STATE OF MICHIGAN
DEPARTMENT OF ENVIRONMENTAL QUALITY
GAYLORD FIELD OFFICE

September 13, 2017

SUBJECT: Information Request
Submission Number: 2RD-DFDK-Y35G
County: Emmet and Mackinac
MiWaters Site Name: 24-Line 5 Enbridge Straits Anchors
Project Name: 2017 Line 5 Anchor Installation Project

The Michigan Department of Environmental Quality (MDEQ), Water Resources Division (WRD), has received and reviewed your Joint Permit Application (JPA) materials and supplemental information for the installation of 22 anchors on Line 5 in the Straits of Mackinac. The WRD has also considered extensive public comments received on the application, as well as information provided during consultations with federally-recognized Indian Tribes in Michigan. In addition, the MDEQ received information verbally from Enbridge Pipelines (Lakehead), LLC (Enbridge) on August 30, 2017, and in a letter dated September 8, 2017, indicating that the external coating of the pipelines had been damaged at certain locations, exposing bare metal in some instances, apparently as a result of past pipeline anchor installation work.

Figure 2b

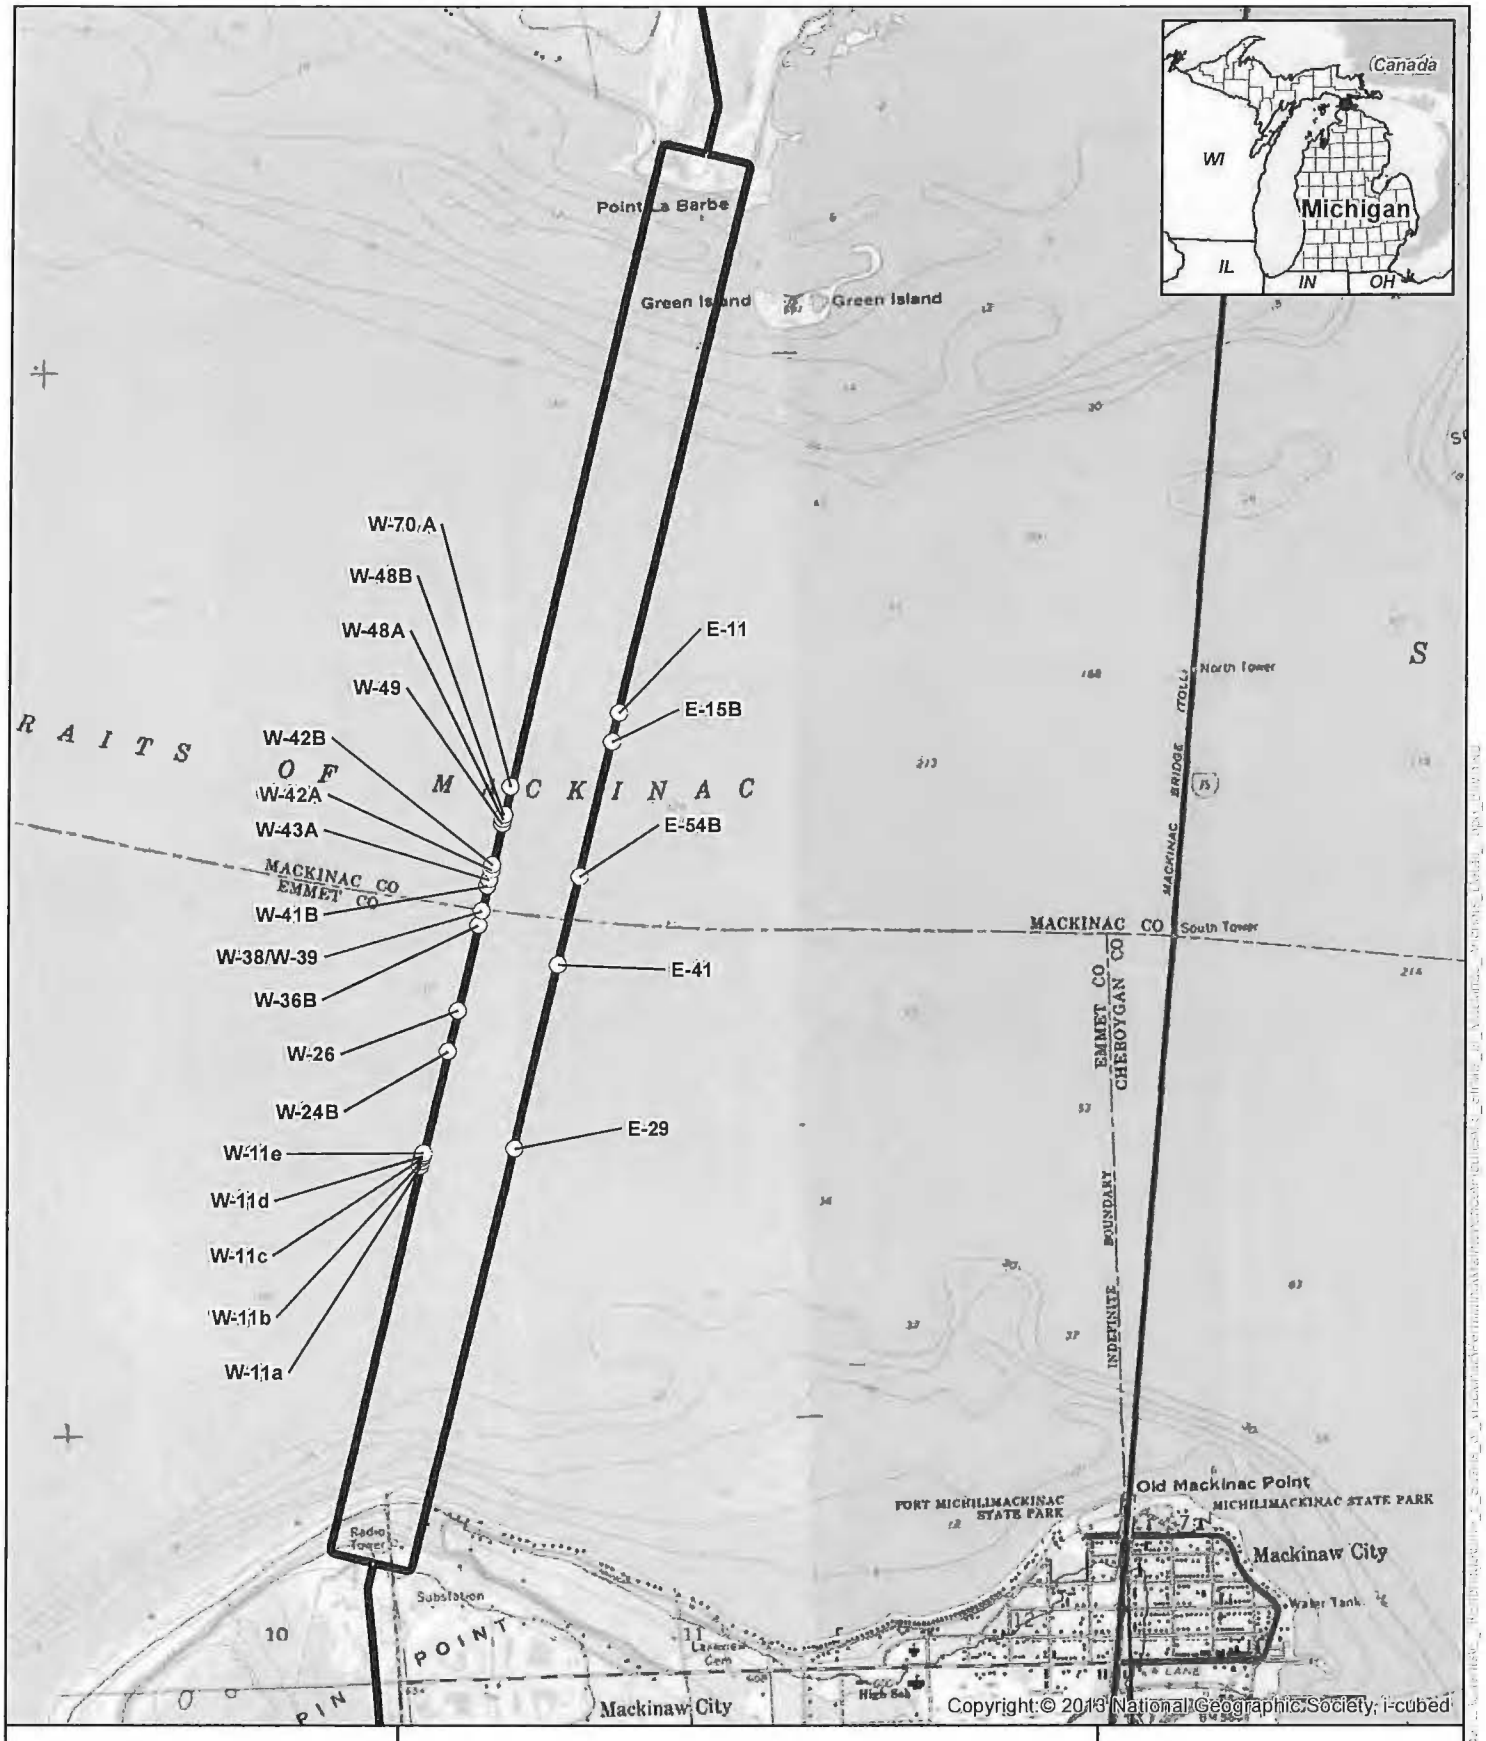
(b) Explain the reason for decreasing the span distances at the specified anchor locations on the west pipeline designated in the permit application as W-11a through W-11e, W-36B through W-42B, and W-49 through W-70A (see enclosed map).
